**ADDENDUM #2
TO SPEC. 05-058**

**Pine Lake Road Widening 40th to 60th Street from
Thompson Creek to Shadow Pines
CIP 700014**

**Pine Lake Road Widening 40th to 61st Street
& S. 56th Street from
Thompson Creek Blvd. To Shadow Pines Drive.**

WATER

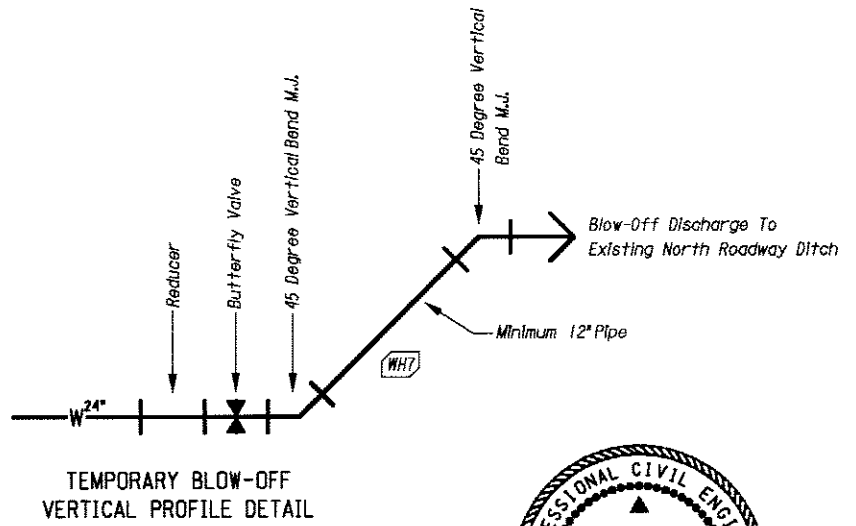
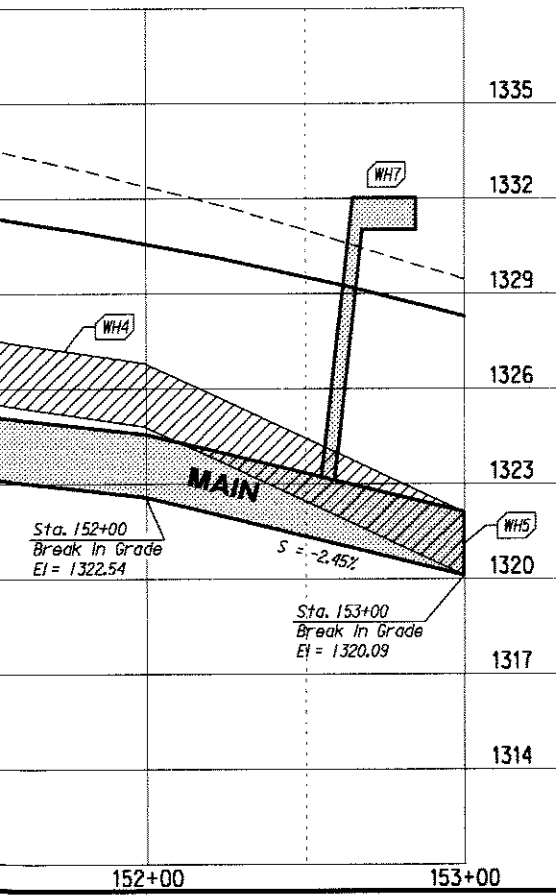
Plan Sheet 77: Add detail for water main "Temporary Blow-Off Vertical Profile." See attached sheet for detail.

Plan Sheet 77a: Add the following note: "The Contractor shall verify the elevation of the water main from Station 161+77 to Station 163+88 prior to ordering fittings."

- WH7** Contractor To Furnish And Install Temporary D.I. Water Main, Reducer, Valve, Fittings And Restraints For Temporary Blow-Off To Use During Testing, Disinfection, And Flushing Of Relocated Main. Use Minimum 12" Water Main For Blow-Off. (Reducer, Valve, Pipe, Fittings And Restraints For Temporary Blow-Off Are Subsidiary To 24"D.I. Pipe Water Main.)

NOTE: Contractor Shall Build **WH1**, **WH2**, & **WH5** After Completion Of Testing, Disinfection And Flushing.
